UNITED STATES PATENT AND TRADEMARK OFFICE

Office Action Summary	Application No. 10/724,812	Applicant(s) OKADA, TSUTOMU	
	Examiner DIANE YABUT	Art Unit 3734

DETAILED ACTION

FIG. 1

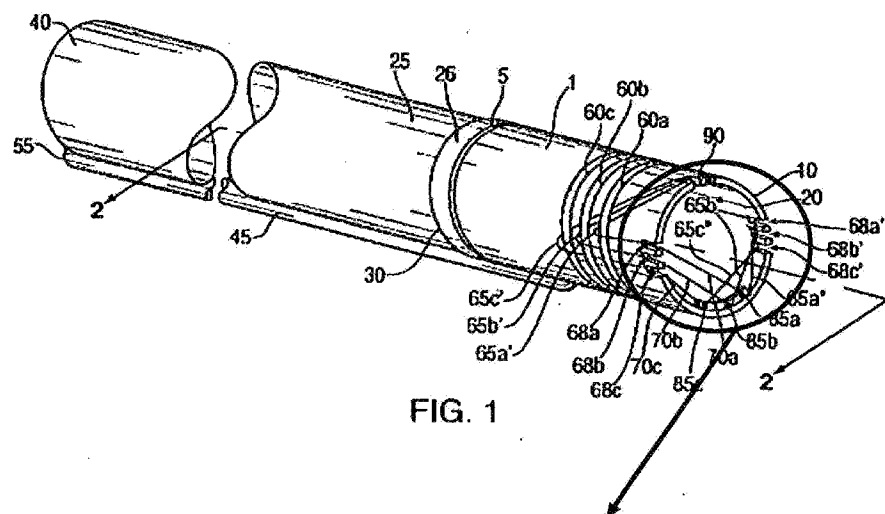
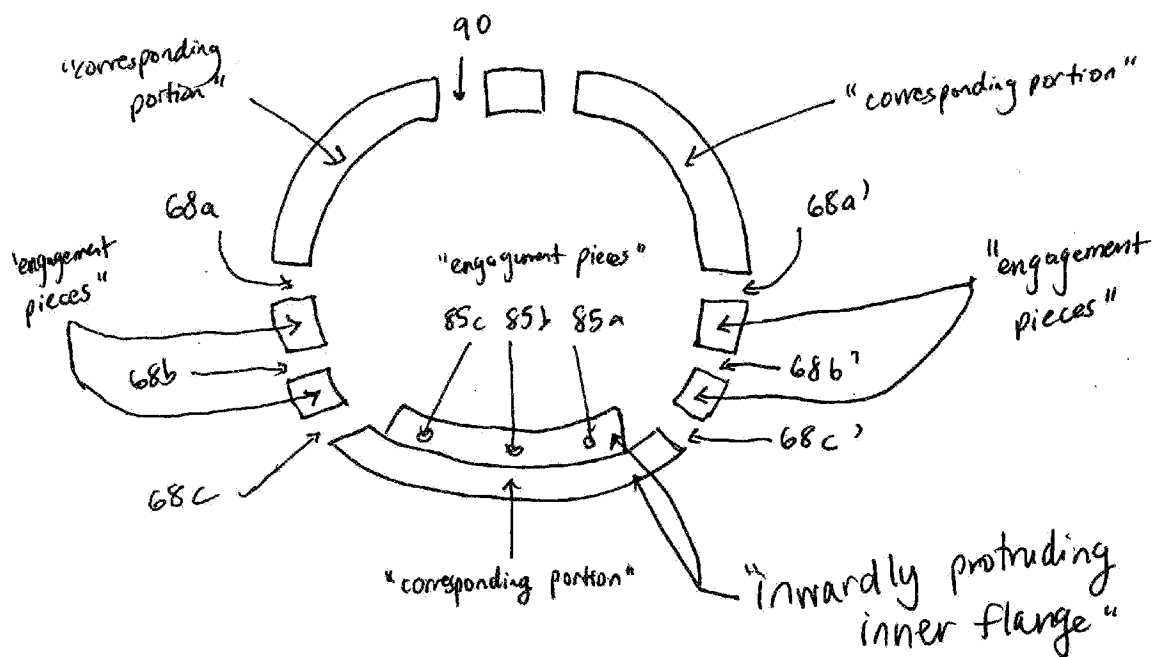
Chu teaches holding mechanism for a snare wire **70** that has a plurality of engagement pieces (adjacent to **90**, **68a-c**, **68a'-c'**) and a plurality of corresponding portions (in between **68a-c** and **90**, and **90** and **68a'-c'**) which hold the distal end portion of the snare wire between the engagement piece and the corresponding portion, said plurality of engagement pieces and being respectively distanced from each other in a circumferential direction of the circular end portion, and each of the engagement pieces is sectioned from the corresponding portion by a pair of vertical notches **90**, **68a-c**, **68a'-c'** which are distanced at the circular end portion in the circumferential direction and formed at a substantially right angle with the circumferential direction in that they possess a width (Figures 1 and 4). See annotated Figure 1 below.

Chu also discloses the plurality of engagement pieces (adjacent **68a-c** and **90**, and **90** and **68a'-c'**) being arranged in the same interval in the circumferential direction and each of the engagement pieces and each of the corresponding portions (in between **68a-c** and **90**, and **90** and **68a'-c'**) directly contacting opposite sides of the end portion of the snare wire to hold the end portion therebetween (Figure 1).

The inner flange (at distal end of **10**) has a plurality of lateral notches **90**, **68a-c**, **68a'-c'** extending in the circumferential direction, and each said pair of vertical notches extend toward the cylindrical wall from both ends of each lateral notch and the circular end portion has a plurality of lateral notches extending in the circumferential direction between the inner flange and the cylindrical wall, and each said pair of vertical notches **90**, **68a-c**, **68a'-c'** extend toward the cylindrical wall from both ends of each lateral notch (Figure 1).

Chu also discloses the corresponding portion (in between **68a-c** and **90**, and **90** and **68a'-c'**) having a flange provided so as to inwardly protrude from the cylindrical wall, the engagement piece (adjacent **90**, **68a-c**, **68a'-c'**) having separation portions separated from each other by a notch portion formed in the inner flange, and the snare wire is supported between the flange and the separation portions (Figure 1).

Chu discloses the engagement pieces and the corresponding portions in between **68a-c** and **90**, and **90** and **68a'-c'**) being alternately arranged in the circumferential direction of the circular end portion (Figure 1).
